Access Compliance Report

Public Rights-of-Way

Intersection ID: 31302	Main Street: BOYNE_RD	Cross Street: EBEN_DR	Location: SW
ADA ID: 8B1C85236015	Ramp Type: PerpDiag	Initial Pass/Fail: Fail	Overall Compliance: No
		Severity Score: 12.5

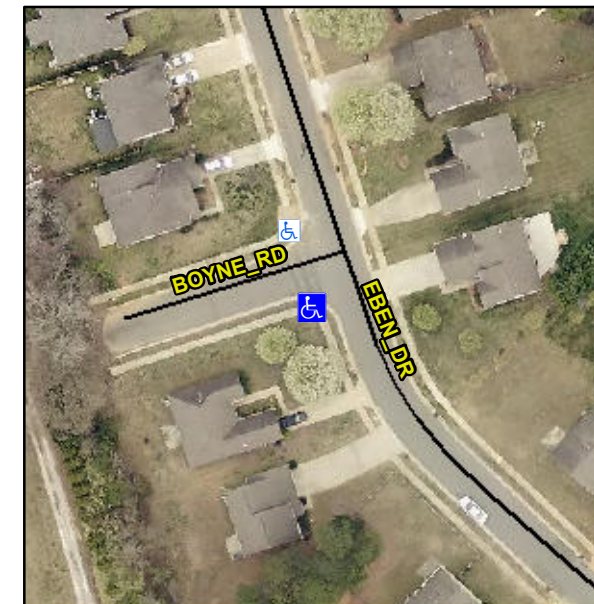
Compliance	Description	Data	Compliance	Description	Data
N/A	Ramp Length (in)	50.5	No	Ramp Slope (%)	9.1
Yes	Ramp Width (in)	50.5	Yes	Ramp XSlope (%)	2.0
N/A	Flare Type LT	N/A	N/A	Flare Type RT	N/A
N/A	Flare Slope LT (%)	N/A	N/A	Flare Slope RT (%)	N/A
N/A	Flare Traversable LT?	N/A	N/A	Flare Traversable RT?	N/A
N/A	Landing Length (in)	N/A	N/A	DWS Provided?	N/A
N/A	Landing Width (in)	N/A	N/A	DWS Contrast?	N/A
N/A	Landing Slope (%)	N/A	N/A	DWS Length (in)	N/A
N/A	Landing X Slope (%)	N/A	N/A	DWS Full Width?	N/A
N/A	Landing Curb? (Y/N)	N/A	N/A	DWS Offset (in)	N/A
N/A	Shared Landing?	N/A			
N/A	Gutter Ponding?	N/A	N/A	Gutter Slope (%)	N/A
N/A	Gutter Lip Ht (in)	N/A	N/A	Gutter X Slope (%)	N/A
N/A	Painted X Walk1?	No	N/A	Painted X Walk2?	No
	X Walk 1 Direction	To N		X Walk 2 Direction	To E
N/A	X Walk 1 Width (in)	N/A	N/A	X Walk 2 Width (in)	N/A
	X Walk 1 Slope (%)	1.3		X Walk 2 Slope (%)	4.1
	X Walk 1 X Slope (%)	2.3		X Walk 2 X Slope (%)	1.2

N/A	Ramp inside XWalk1?	N/A	N/A	Ramp inside XWalk2?	N/A
	Road Slope (%)	2.5	N/A	Clear Space?	N/A
	Road X Slope (%)	5.1	N/A	Clear Space to XWalk (in)	N/A
N/A	Any Obstructions?	N/A	N/A	Storm Grate/Utility Hazard?	N/A
	Obstruction Type			Storm Grate/Utility Type	
		N/A			N/A
		Yes		Surface Condition? (G/P)	Good

Remove & Replace Curb Ramp With Two New Directional Ramps or Equivalent.
